HISTORIC AND DESIGN REVIEW COMMISSION

HDRC CASE NO: 2018-091
ADDRESS: 809 S ST MARYS
LEGAL DESCRIPTION: NCB 738 BLK 1 LOT N IRR 120 OF 1 OR A1,S IRR 51.6 OF N 117 OF 1&2,NE TRI OF 6 OR A7
ZONING: C-2 IDZ, H
CITY COUNCIL DIST.: 1
DISTRICT: King William Historic District
APPLICANT: Xavier Gonzalez/GRG Architecture
OWNER: Kenton and Nancy Kimball
TYPE OF WORK: Exterior Modifications - Conceptual
APPLICATION RECEIVED: March 16, 2018
60-DAY REVIEW: May 15, 2018
REQUEST:

FACADE MODIFICATIONS
KING WILLIAM
PROFESSIONAL BUILDING
809 S. ST. MARY'S,
SAN ANTONIO, TX, 78207

PARTIAL FRONT
ELEVATION AND
WALL SECTION

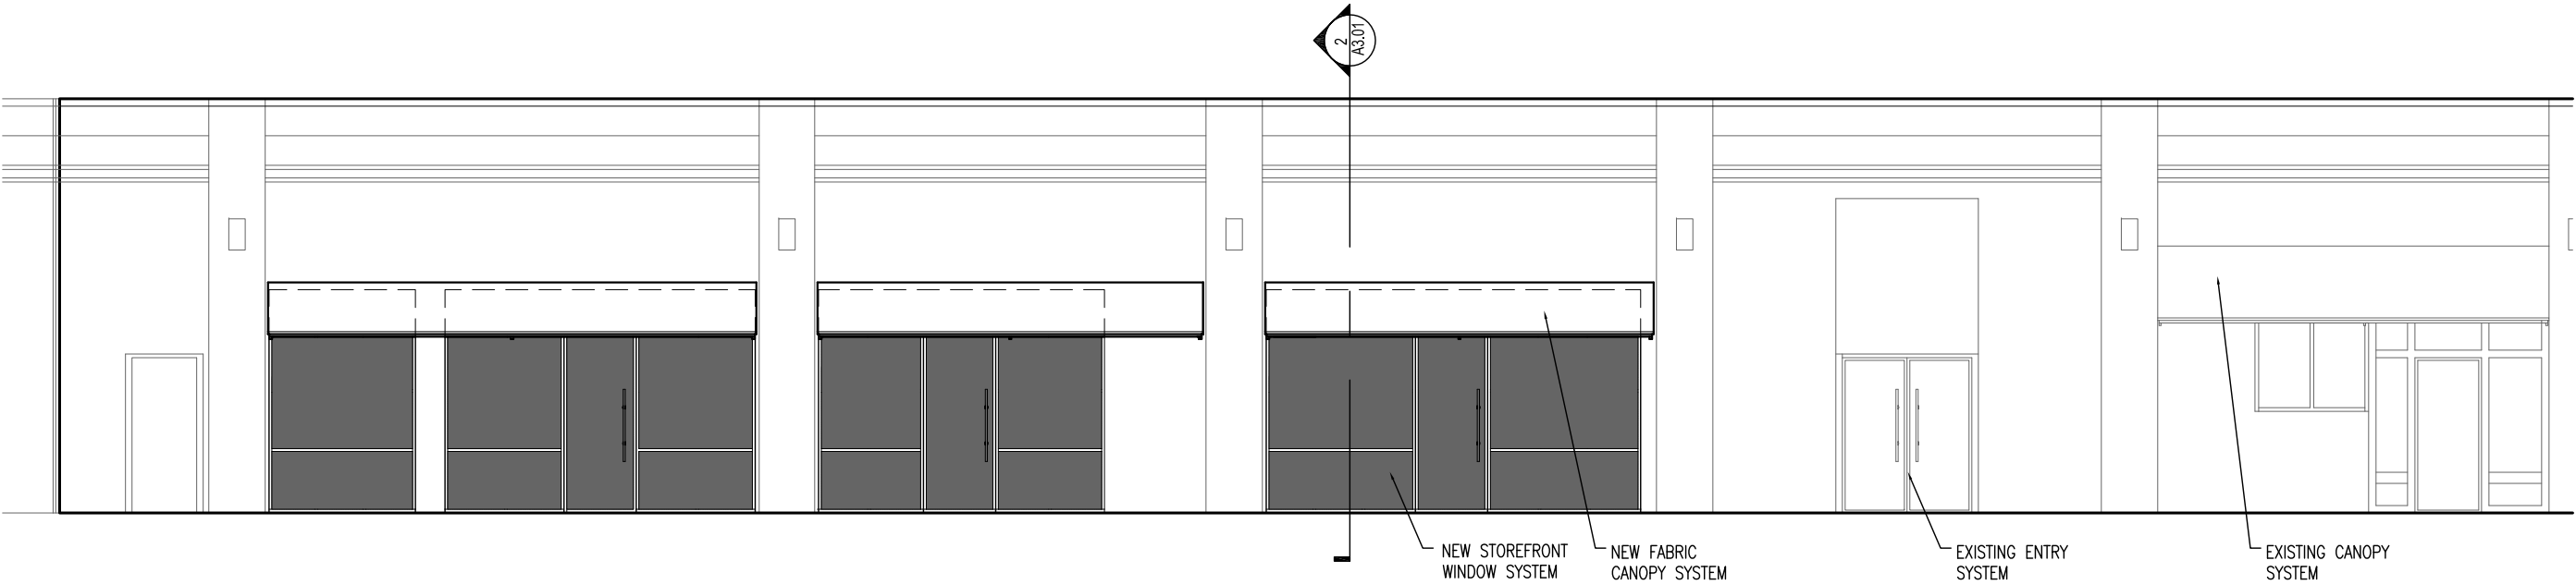
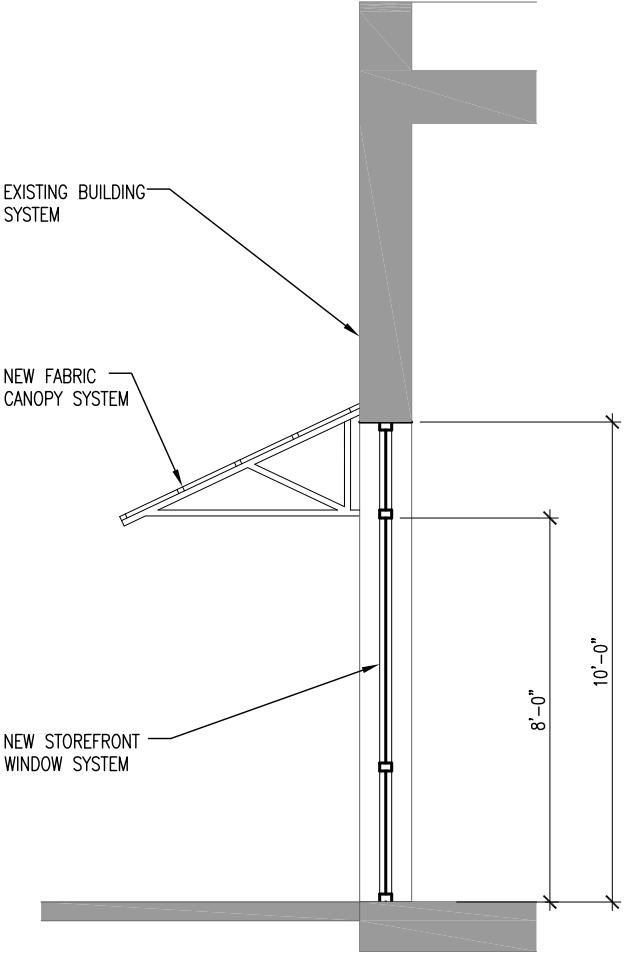
- c. STOREFRONT SYSTEM – The applicant has proposed to install four glass storefront systems into St Mary's (east) façade. The Guidelines for Exterior Maintenance and Alterations 10.B.i. notes that new façade elements that alter or destroy the historic building character should not be introduced and that the architectural rhythm of the block should be preserved. While the existing historic structure features no existing storefront system, many historic structures on S St Mary's Street do. Examples have been provided by staff in the case exhibits.

- d. STOREFRONT SYSTEM – The applicant has proposed a storefront system that features an overall height of 10' – 0" – eight feet front the finished floor to the transom windows and transom height of two feet. The proposed storefront systems feature widths of 6' – 0"; 10' – 0"; 10' – 0"; and 16' – 4". Historic structures on S St Mary's feature storefront systems with pony/knee walls ranging in height from 18 to 24 inches, which the applicant has not included. This is inconsistent with the Guidelines for Exterior Maintenance 10.B.i. Staff finds that pony/knee walls, mullion widths and installation depths should be consistent with those found historically in the vicinity on S St Mary's. Additionally, the storefronts should feature uniform widths, centered on the existing column bays which translate to the brick façade.

- e. AWNINGS – The applicant has proposed to install awnings above each storefront system. Per application documents, the applicant has proposed for the awnings to span the width of each existing column bay above the proposed storefront systems and cover the proposed transom windows. The proposed awnings do not feature widths that match the storefront openings.

- 1. Staff recommends approval of item #1, the installation of storefront systems with the following, previously approved stipulations. These stipulations are consistent with those approved during conceptual review.
 - i. That the proposed storefront systems feature mullion widths and depths that are comparable to those found historically in the district.
 - ii. That the proposed storefront system doors be centered between column bays.
 - iii. That a brick knee wall feature a height of approximately (16) inches as noted by the applicant.
 - iv. That the proposed storefront system features an overall profile that is comparable to those found on adjacent structures on S St Mary's.
- 2. Staff recommends approval of item #2, the installation of awnings with the stipulation that awning widths should match the width of the proposed storefront systems.
